Fort Calhoun Station
Unit No. 1

Title: CORE OPERATING LIMIT REPORT

Reason for Change: Allow increase operating space for
DNB-LCO monitoring without requiring
use of BASSS.

R4

FIGURE
5

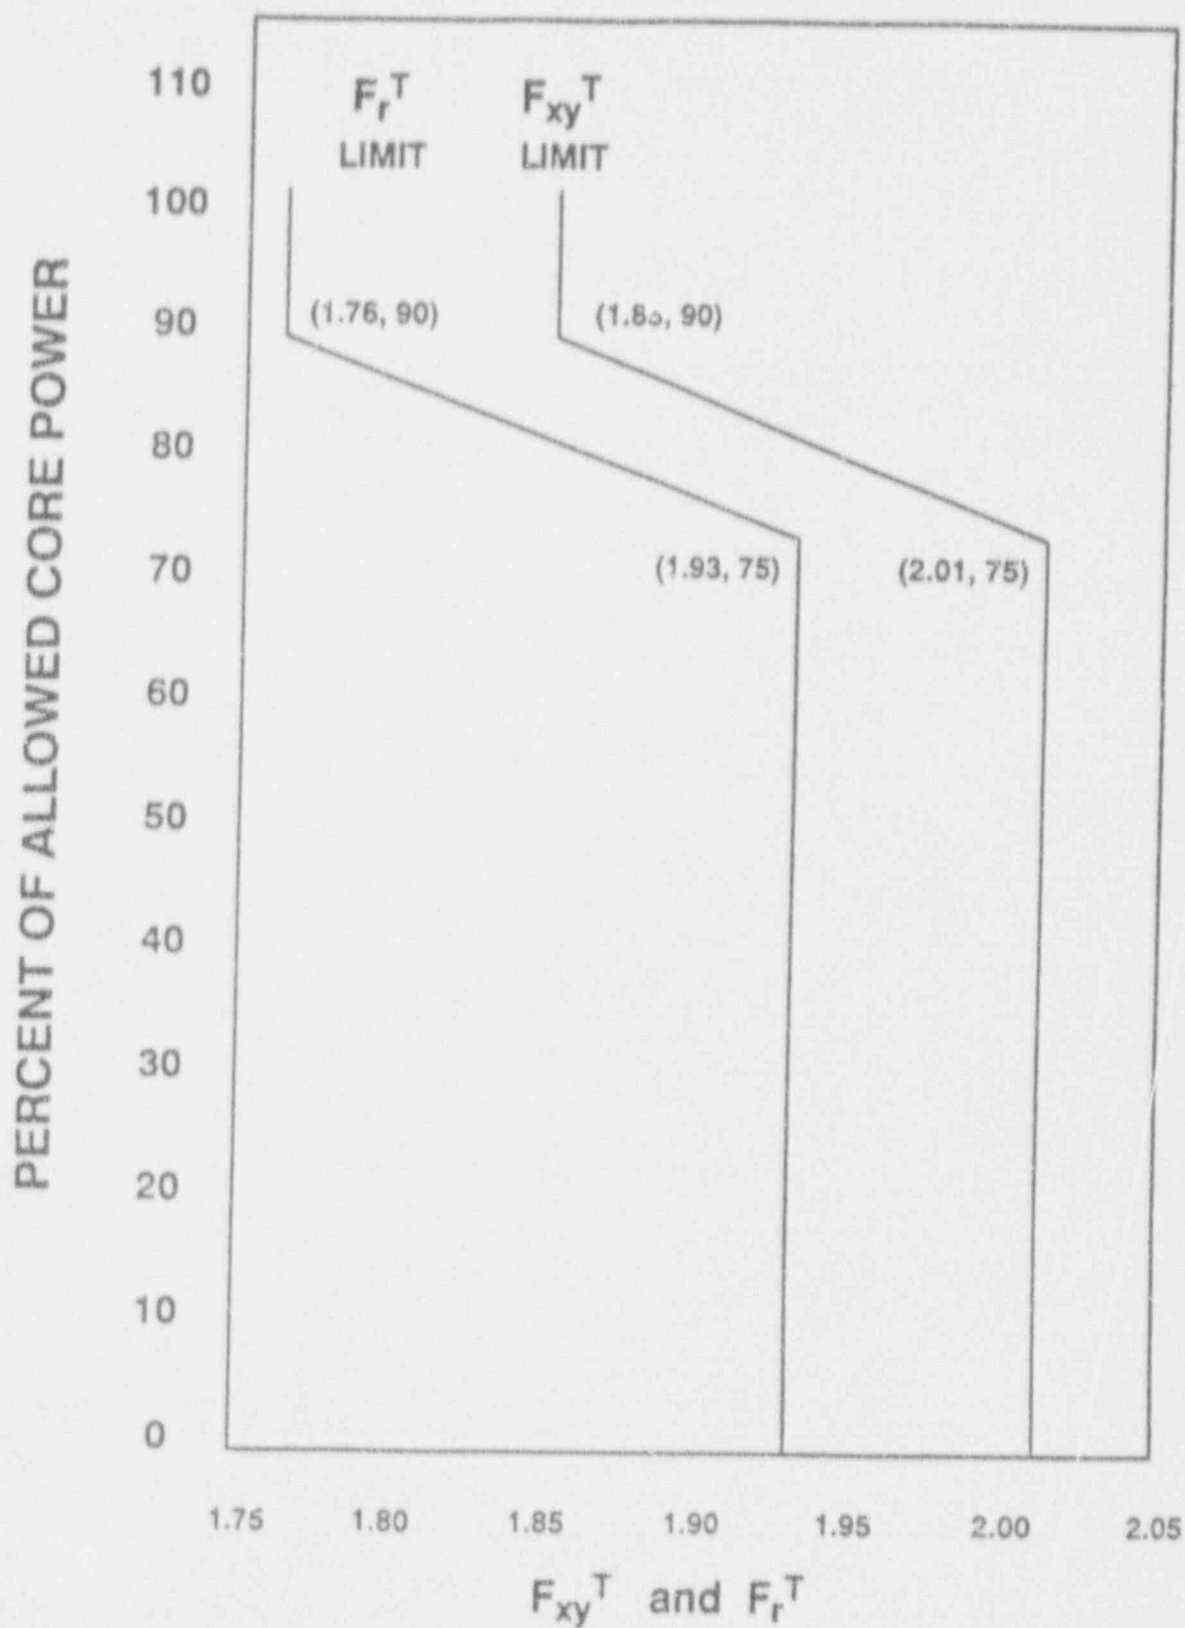
Core power shall be maintained within the limits established by the Better Axial Shape Selection System (BASSS) for CEA insertion of the lead bank of <65% (i.e., greater than or equal to 44.1 inches withdrawn) when BASSS is operable, or within the limits of Figure 5.
